ORIGINATION FORM

Proposed Revisions to a Standard Plans Index (Please provide all information — Incomplete forms will be returned)

Index Number: 700-106
Sheet Number (s): 1 & 2
Index Title: Rural Narrow Bridge Treatment

LAST REVISION 11/01/17	DESCRIPTION: 11/01/20	FDOT FY 2020-21 STANDARD PLANS	RURAL NARROW BRIDGE TREATMENT	INDEX 700-106	SHEET 1 of 2
---------------------------	------------------------------	--------------------------------------	-------------------------------	------------------	-----------------

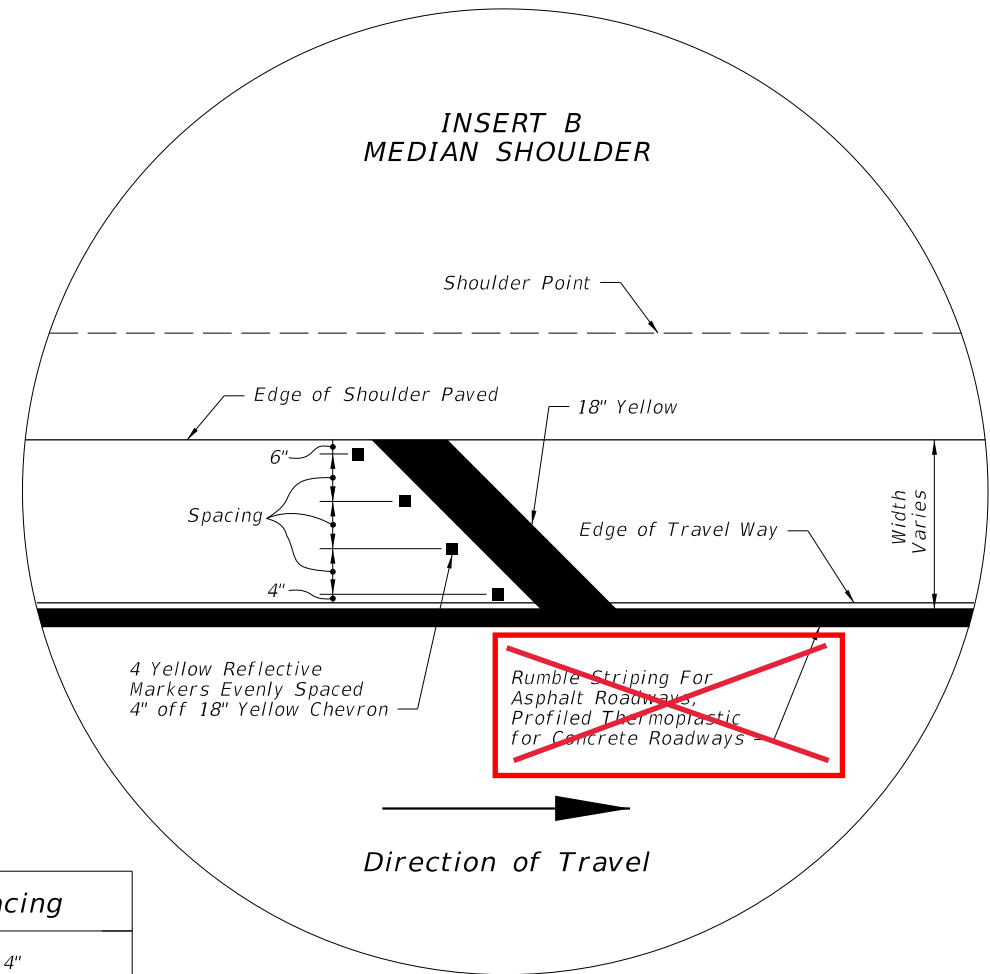
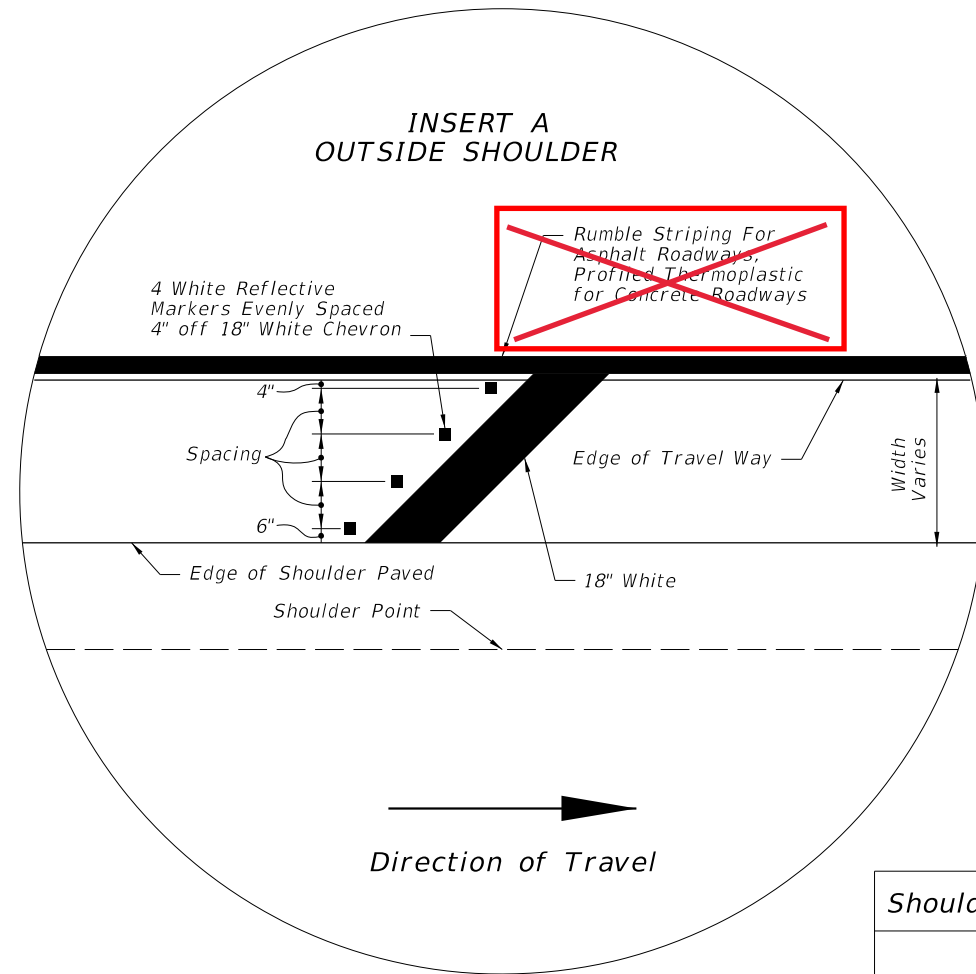
Sheet 1: Updated the guardrail layouts illustrated to include Parallel Approach Terminals.

Updated Guardrail layout to include Parallel End Treatments.

Used Index 536-002, Sheet 2, Detail S (shown left).

The Department no longer uses Flared Approach Terminals for new installations of guardrail; therefore, for consistency with Index 536-001 details, the layouts shown on Sheet 1 are updated to show Parallel Approach Terminals. Sheet 2 references to Rumble Striping were removed for consistency with current policy (RDB18-03).

SHEET
2 of 2

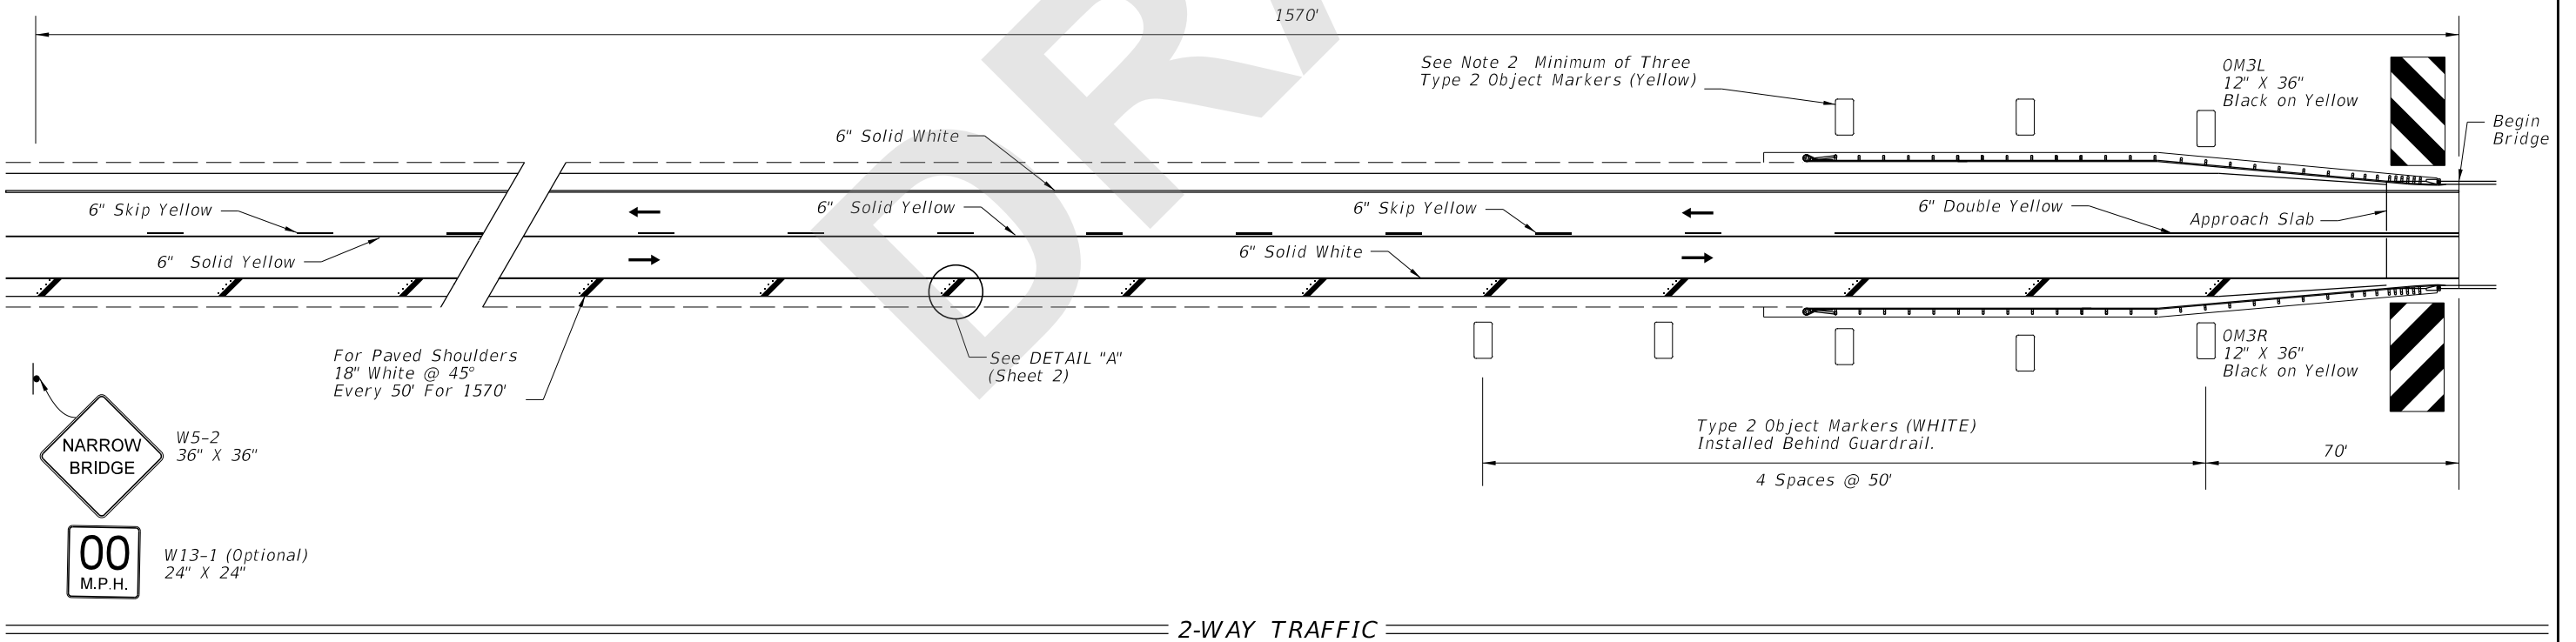
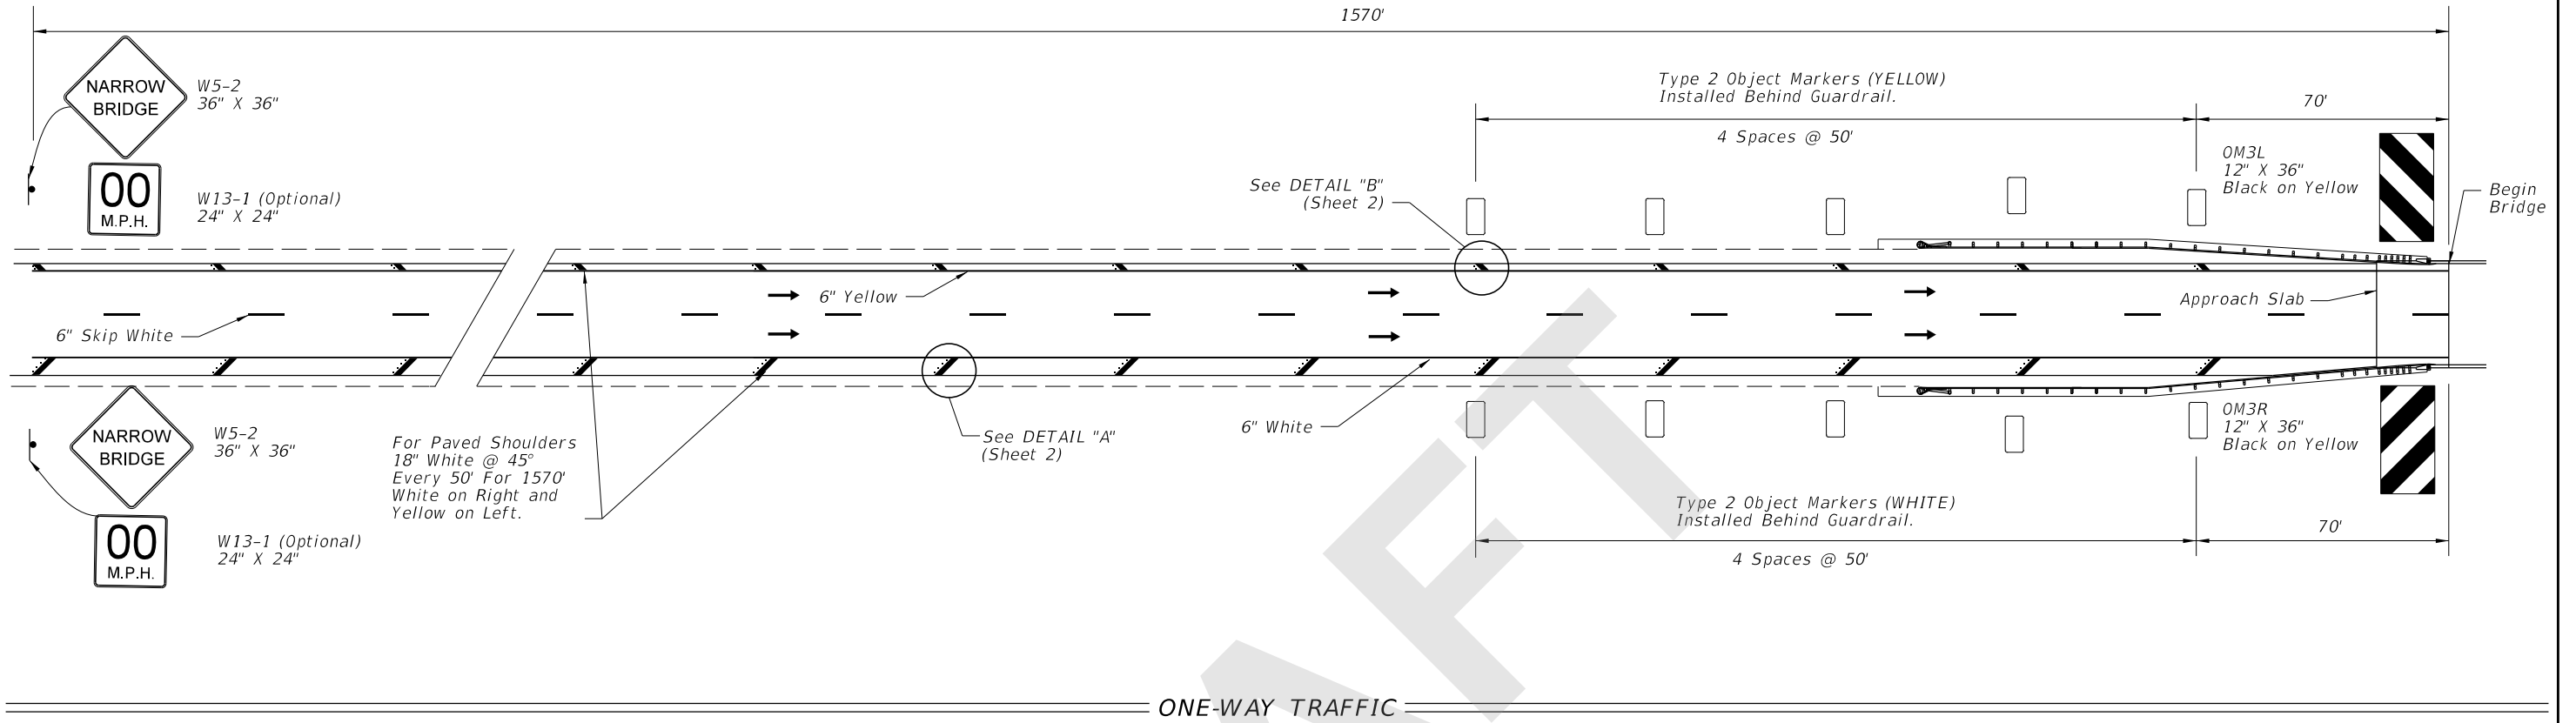
Sheet 2: Removed call-out references to the Rumble Striping and Profiled Thermoplastic in the 'INSERT A' and 'INSERT B' details. Added new Note #5, to refer to the Plans for the installation Audible and Vibratory treatments.

Added Note 5

5. Install Audible and Vibratory treatments (e.g., ground-in rumble strips or profiled thermoplastic) in accordance with the Plans.
